**AGENDA ITEM SUMMARY / STAFF REPORT**  
**FLORENCE PLANNING COMMISSION**

**ITEM NO: 4**  
Meeting Date: February 24, 2023

**ITEM TITLE:** Fairway Estates Phases 2-4  
PC 21 39 SUB 03 – Tentative Subdivision Plan  
PC 21 40 PUD 02 – Preliminary Planned Unit Development (PUD)  
AR 21 21 SIR 14 – Site Investigation Report

**FINDINGS OF FACT  
FLORENCE PLANNING COMMISSION  
Exhibit "A"**

Figure 10-35(3): Examples of Fire Lane Turn-Around

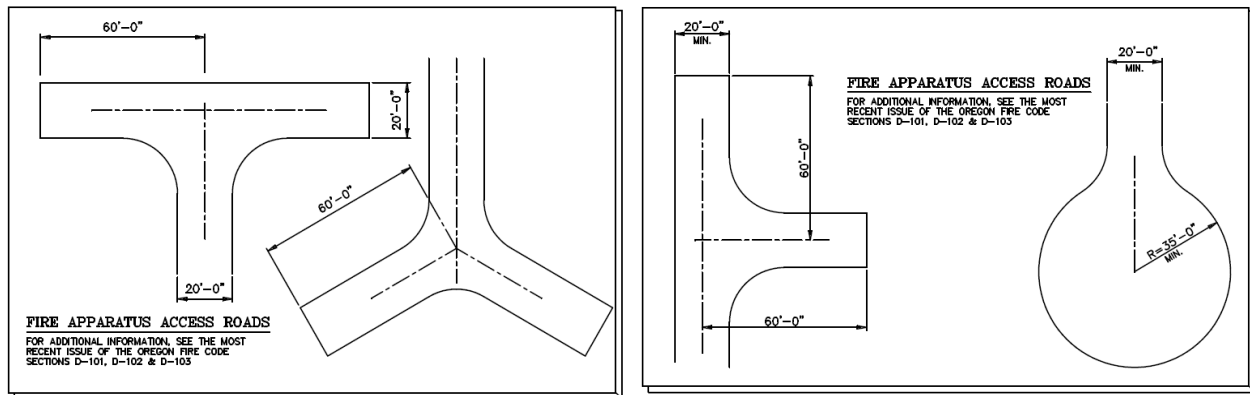
Siuslaw Valley Fire and Rescue provided comments on this project where a turnaround was required between phases and on drive aisles greater than 150' and that a secondary access or sprinklers were required. As applicable to this criterion each phase will require a temporary turn around meeting the criterion of Figure 10-35(3). For the driveway in the northeast corner of Phase 4 the pavement shall be a minimum of 18' wide with 20' of unobstructed aisle width that is signed “no stopping or parking” and include a turnaround meeting Figure 10-35(3) until through connection onto Rhododendron Drive or east to Oak St. is available from the northern city owned property. **[Condition]**

**Figure 10-36(5): Street Intersection**

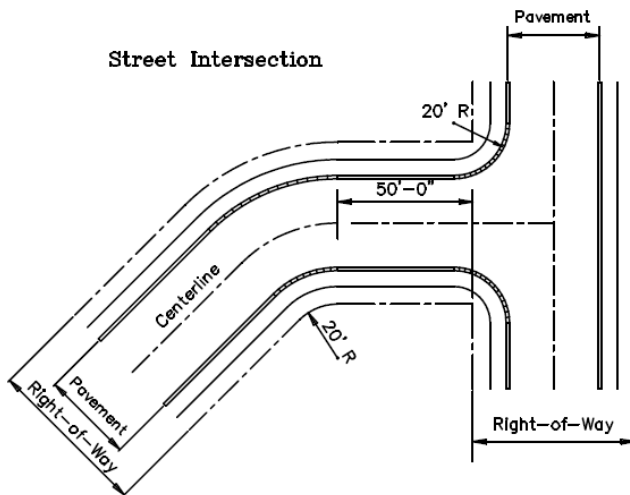
Two elbow corners are proposed. The eastern one also has an intersection angle less than 80 degrees. The applicant is requesting a modification to the criteria using the PUD process. They cite previous PUD property layout and an effort to not have a cul-de-sac as the reason for the design of elbows and reduced intersection angle.
